Markup GTR9 vs. Amendment 3

Measuring Point Amendment 3 vs. 1PoC

Task Force „GTR9 Amendment 3“ Technical Working Subgroup

28 September 2021

Wrong interpretation of GTR9 in its original version:

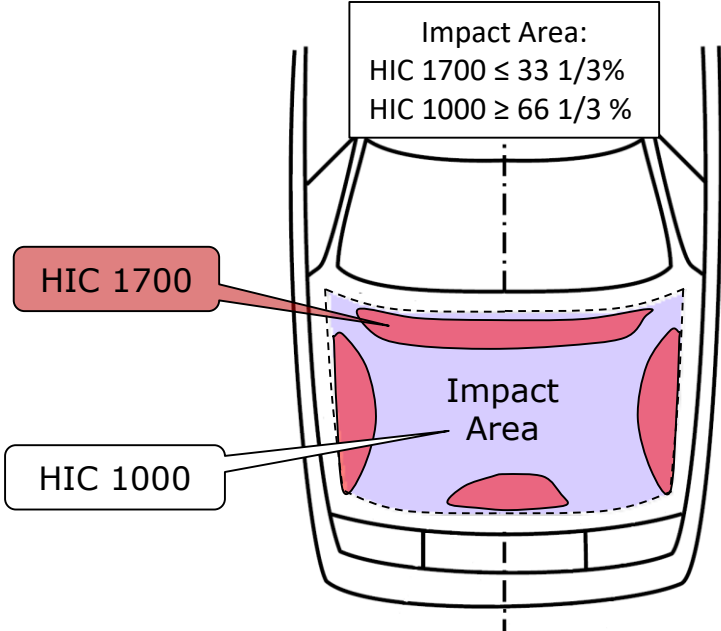
A HIC value can only be calculated and assessed for areas in which a test has been performed. A HIC cannot exceed any value over any (test) area that cannot be tested. This leads to the conclusion that 5.2.3 and 5.2.4 exclusively refer to areas that can be tested. Thus, a zone prediction within the „offset zone“ (i.e. between the SLRs, the BRRL, the BLERLs and 82.5mm inboard) is not required and makes no sense.

The illustration in Amendment 3 is a clarification of the one in GTR9. In GTR9 it was missed to name the SRLs and the dashed line as the „offset line“.

GTR9 in its original version misses some important details:

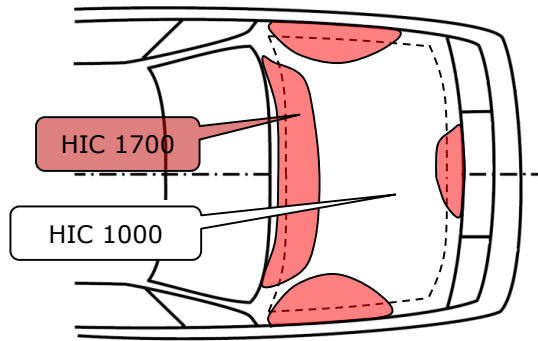
- the on-time introduction of the offset lines
- the initial contact is referred to the vertical longitudinal impactor centreplane.

This could lead to the wrong interpretation of adding the „offset zones“ to the „HIC determination zones“ (1/3 HIC 1700 and 2/3 HIC 1000).

However, a better solution is clarifying that the HIC determination zones refer to the impact area (i.e. w/o the „offset zones“), only → Draft Amendment 3.

Enlarged share of HIC 1700 zones:

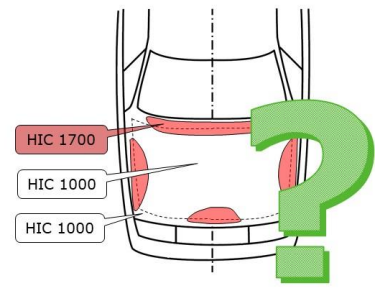
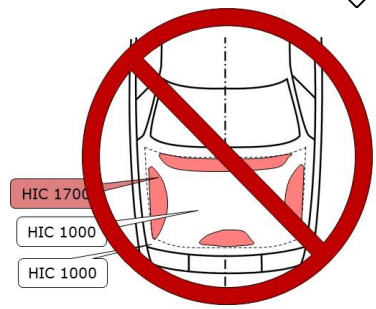
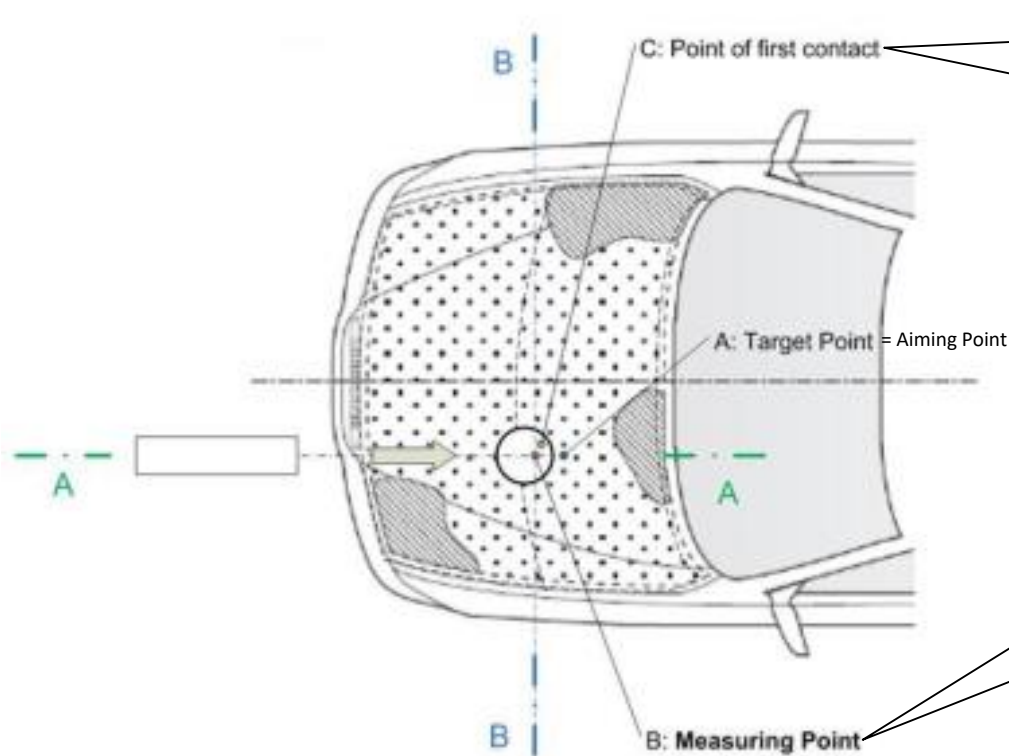
An abuse of this wrong interpretation could result in an enlarged share of HIC 1700 zones in the impact area. A countermeasure would be banning a prediction of adjacent zones with an inferior performance.

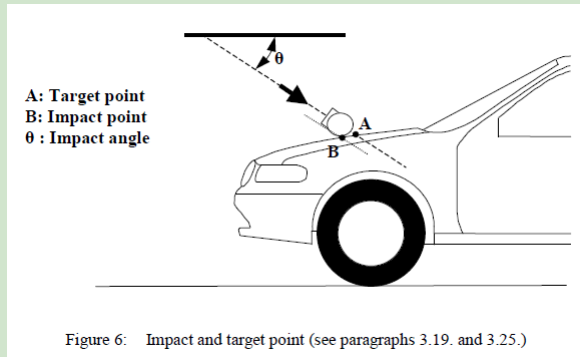
3.19 in GTR9 states that the relation between GTR9 impact point to target point is described by angle of travel and vehicle contour in Figure 6. Figure 6 is a two-dimensional side view/sectional drawing, illustrating the angle and contour on the xz plane, only. This leads to the conclusion that with „angle of travel“ the velocity vector on the xz plane and with the „contour“ the contour projected to the xz plane is referred to. A lateral component is not taken into account for the velocity vector nor the vehicle contour.

Wrong interpretation of GTR9
in its original version:

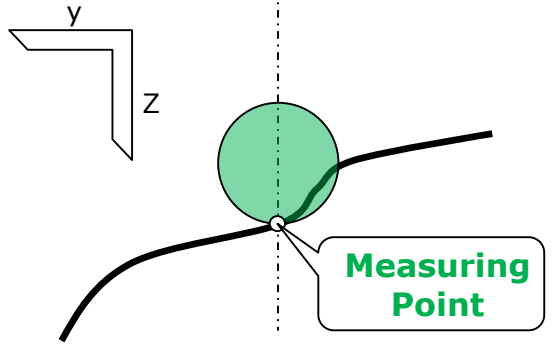
This could lead to the wrong interpretation of allocating the test result to a 1PoC located on a vertical longitudinal plane different to the vertical longitudinal impactor centreplane.

An abuse of this wrong interpretation could result in testing outside the impact area

Since the target point is located on the vertical longitudinal impactor centreplane, the result must be allocated to a point located on the same vertical longitudinal plane.

2010 Kia Forte:

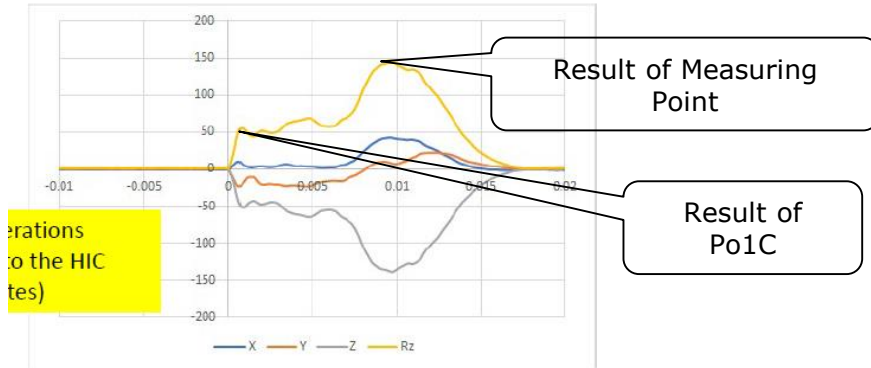
Target and measuring points mainly contribute to the test result.

2010 Buick LaCrosse:

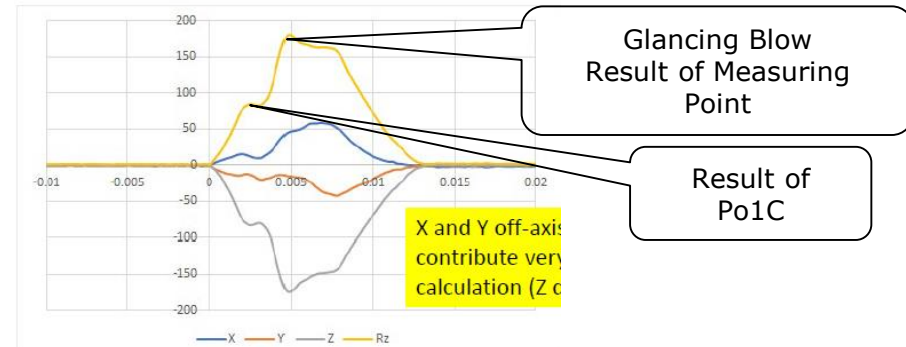
Target and measuring points mainly contribute to the test result.
Calculated HIC value not related to Po1C!

2010 Acura MXD:

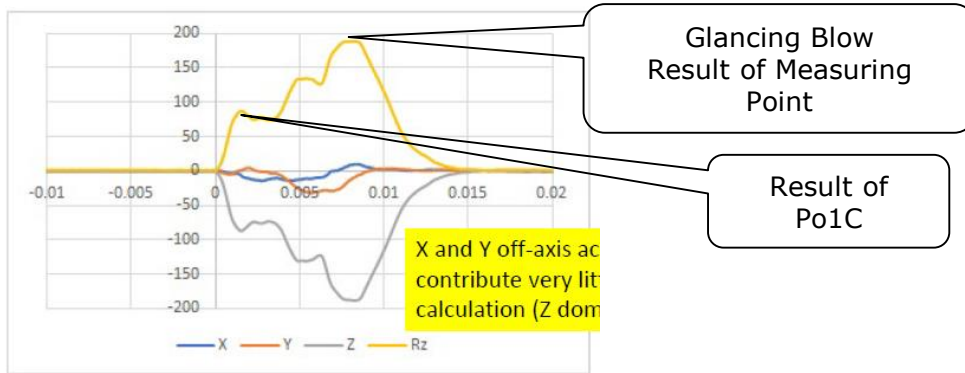
Target and measuring points mainly contribute to the test result.

Since the target point is located on the vertical longitudinal impactor centreplane, the result must be allocated to a point located on the same vertical longitudinal plane.

Calculated HIC value not related to Po1C!
